MEMORANDUM

TO: Ethan Owens, Athletic Facilities Manager, City of Portland
FROM: Megan LaPierre, EI and Scott Hawk, PE
DATE: June 7, 2011
RE: Fitzpatrick Stadium Bleacher Replacement Project – Code Enforcement Inspection

City of Portland Code Enforcement Officer Site Inspection Violations and Comments:

Right Stair Handrail Before

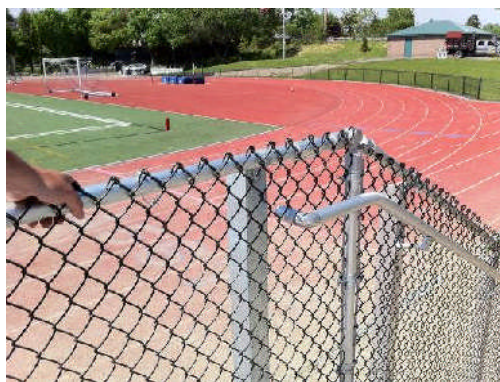
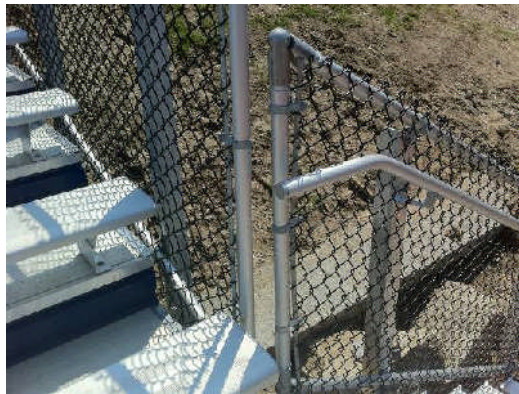
Code Violation – The handrails at the ADA accessible ramp and the bottom stairs do not have returns.

Returns have been added to all stair and ramp handrails. See the photos below for modifications.

Footing Subgrade with Leveling Sand

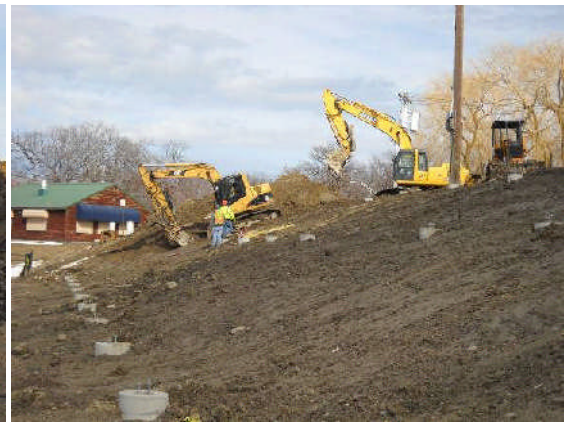
Soil – Verify excavations are extended to proper depth and have reached proper suitable material. Verify materials below column footings are adequate to achieve design bearing capacity = 1,000 psf. Verify all new precast concrete footings are placed on re-compacted grade per geotechnical report and approved shop drawings.

Scott Hawk and Megan LaPierre made several site visits during the installation of the precast footings. All footings were installed at proper depth and on suitable material. When unsuitable material was encountered, the material was removed, and new material was brought to the site. See Attachment C for several email correspondents about foundation installation. See below for photos of foundation installation.
